# UNITED STATES PATENT AND TRADEMARK OFFICE

APPLICATION NO.	FILING DATE	FIRST NAMED INVENTOR	ATTORNEY DOCKET NO.	CONFIRMATION NO.
10/779,749	02/18/2004	Yoshihiro Kimura	H6808.0040/P040	2045
24998	7590	06/02/2005	EXAMINER	
DICKSTEIN SHAPIRO MORIN & OSHINSKY LLP			JOHNSTON, PHILLIP A	
2101 L Street, NW			ART UNIT	
Washington, DC 20037			PAPER NUMBER	
			2881

**Office Action Summary**

FIG. 3A

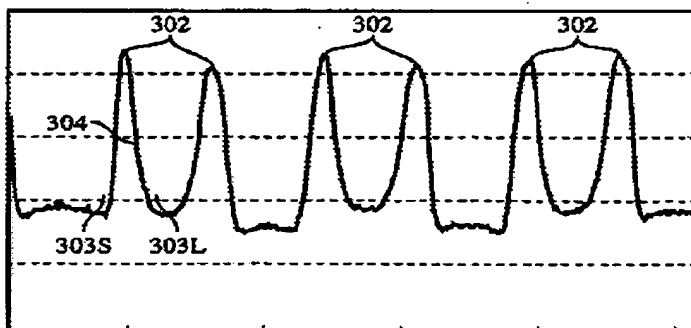
During the examiners construing of the claims in light of figures 3A through 3C the following observations were made;

As stated above in paragraph [0036] above, the lines are the convex portions and the spacings are the concave portions.

**FIG. 3B**

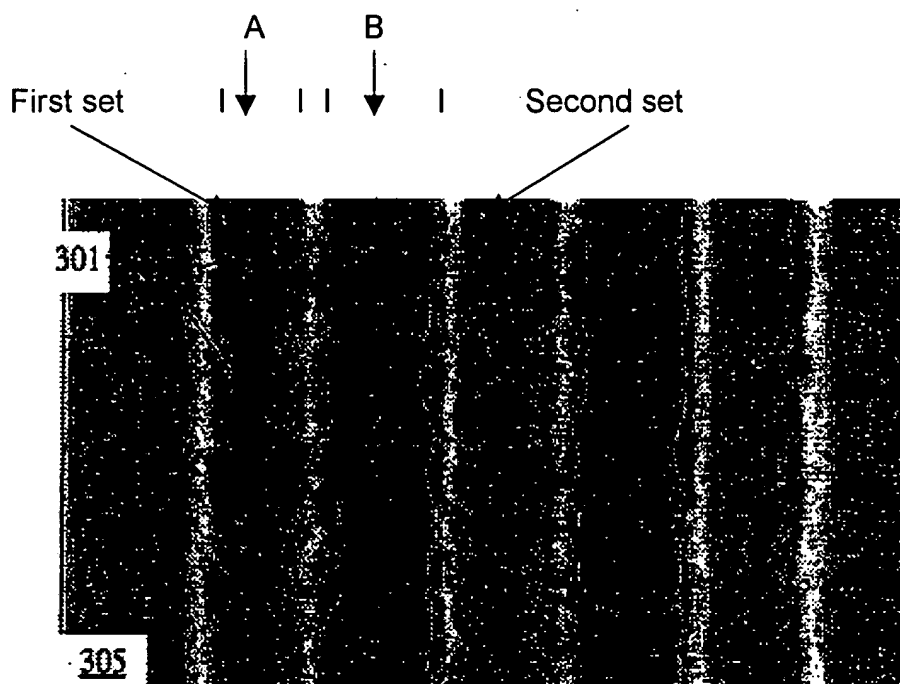
The repetitive pattern of the lines in Figure 3B, has a first set of two lines with spacing A between them, followed by spacing B, and then a second set of two lines with spacing A between them, followed by spacing B; etc., and spacing B is larger than spacing A. It also appears that the size of the spacing B between adjacent lines varies, the far left being largest.

**FIG. 3C**

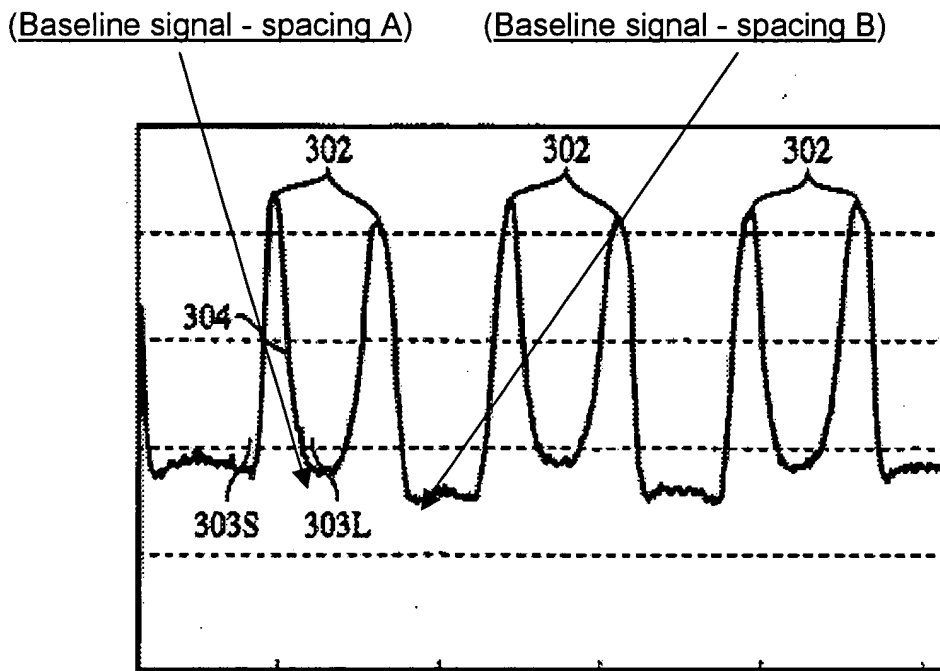
Figure 3C shows the results of beam scanning the pattern in Figure 3B, wherein two peaks 302 were observed for each set of two lines and a baseline signal level between the peaks representing spacing A, followed by a baseline signal level representing spacing B, followed by a second set of peaks 302 and so on across the pattern.

More importantly, for each pair of peaks 302 in Figure 3C, the inside foot 303L of each peak located adjacent spacing A between the pair of peaks 302, appears to converge more gradually than the outside foot 303S of each peak located adjacent any spacing B.

It also appears that the variations in width of repetitive spacing B observed in Figure 3B are likewise faithfully reproduced in Figure 3C.

However, the applicants use in paragraph [0035] of the influence of the secondary electrons or reflected electrons from the edge side walls to define the rate of convergence of the foot of each peak, and therefore convexity and concavity of claims 1 and 2 is ambiguous. For example, in Figure 3C above, the steeply converging foot 303S is clearly the left edge of the first pair of lines 302, which is a convex portion, and gradually converging foot 303L is clearly the right edge of the first line, which is a concave portion, since it is adjacent spacing A.

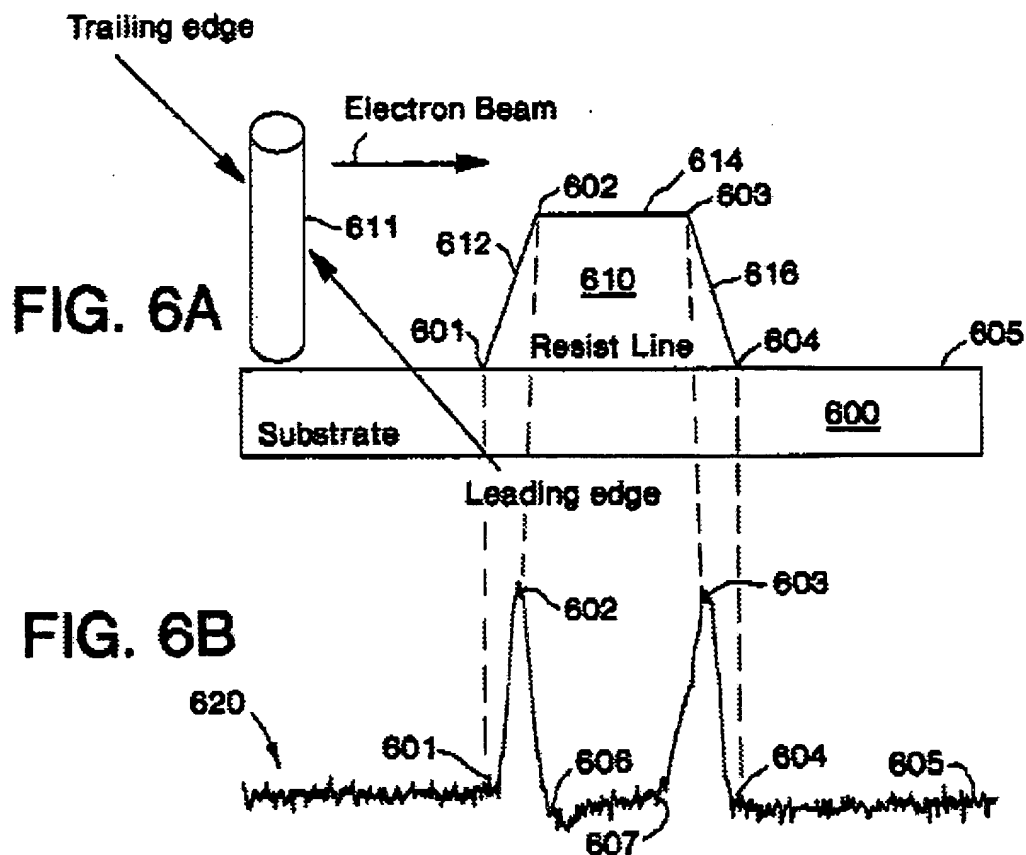
(a) Using a commercially available SEM to perform an e-beam scan across a resist line (convex pattern); forming a profile waveform of escaped electrons

(secondary and reflected electrons), having a peak, as recited in claims 1-4, and 11.

See Column 5, line 43-67; Column 6, line 1-33; Figures 6A, 6B, and 7 below.

It is important to point out here that as the width of the resist line 610 becomes smaller, a single peak representative of the line width occurs as shown in applicants Figure 3C above.

**FIG. 7**

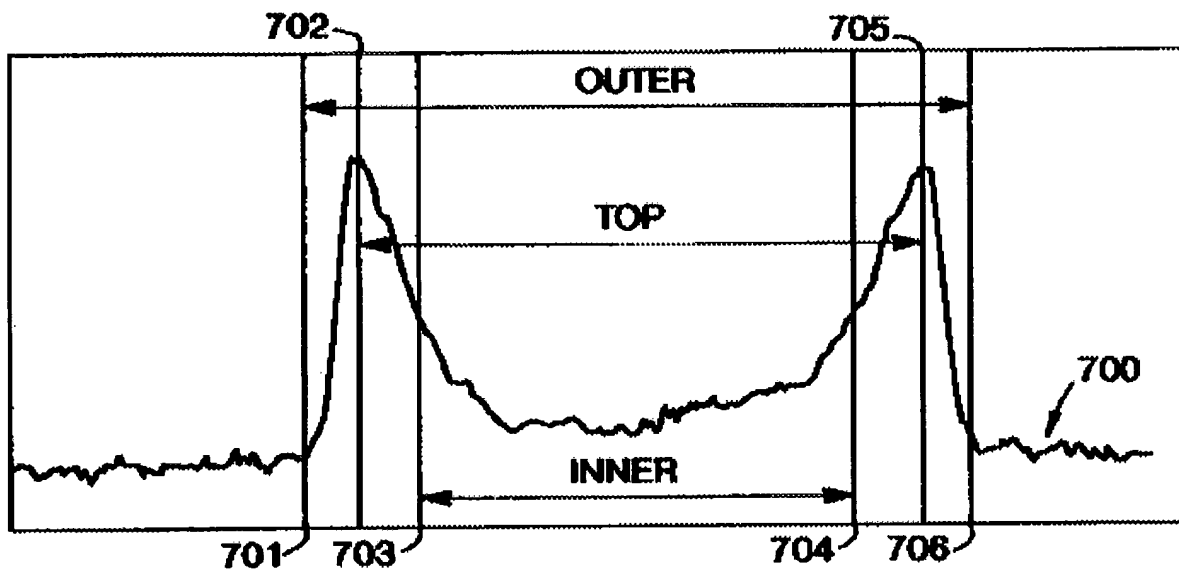
(b) A waveform peak 702, which has steeply sloped regions on either side and one side slopes more steeply to the bottom (foot portion) than the other, where the waveform shape 700 is representative of the resist line (a convex feature). the regions adjacent the peak regions; i.e., from 701 to 702, and 705 to 706, are regions where the

secondary electron signal amplitude is increasing sharply over the baseline amplitude of the substrate, which are equivalent to regions 303S and 303L in applicants Figure 3C above, as recited in claims 1-4, and 11. See Column 6, line 9-33.

(c) One of ordinary skill recognizes that the locations of the points 701-706 may be determined by computing the derivative of the waveform 700, to determine the slope, and selecting the points at which the difference between the slope and the maximum slope reaches a threshold value, as recited in claim 10. See Column 6, line 23-33.
